Response to Submissions

St Aloysius College – Rozelle Campus SSD - 27208140

Prepared by Willowtree Planning Pty Ltd on behalf of St Aloysius College

Figure 2. Proposed pickup/ drop off location (Source: Traffix, 2022)

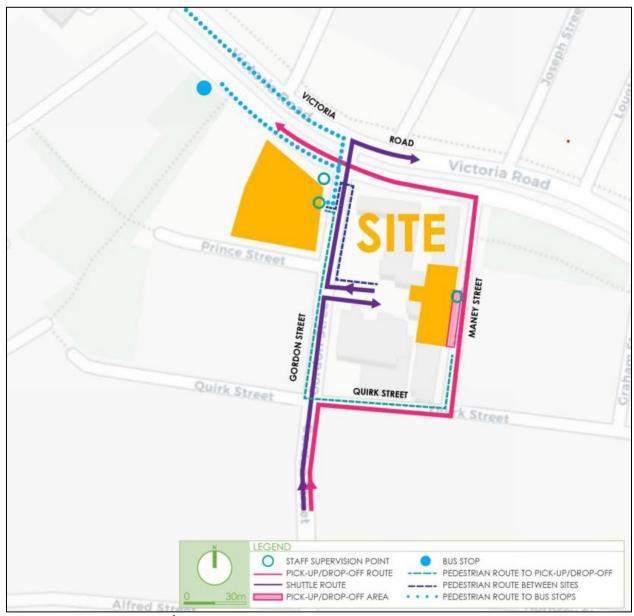
School pick-up and drop-off Arrangement

There is no identified location where students can be picked up or dropped off either by car or bus. The pick-up and drop areas should be located where pedestrian and vehicular conflicts are minimised. The location should consider and incorporate all aspects of student safety, convenience, and comfort.

Drop off and pick up zones should be exclusively available for use during the facility's operating hours with spaces clearly marked accordingly, close to school to avoid unnecessary circulation and re-entering the classified road network.

The proposed pick up and drop off location has been relocated to Maney Street to ensure that queues do not impact nearby intersections.

The pickup and drop off location has been relocated slightly further north on Maney Street, this is to reduce any impacts on the nearby intersections. The revised location is identified in **Figure 2** below. It is considered that these bays would only be required for 30 minute before and after the school day, and at all other hours could be utilised as current resident street parking.
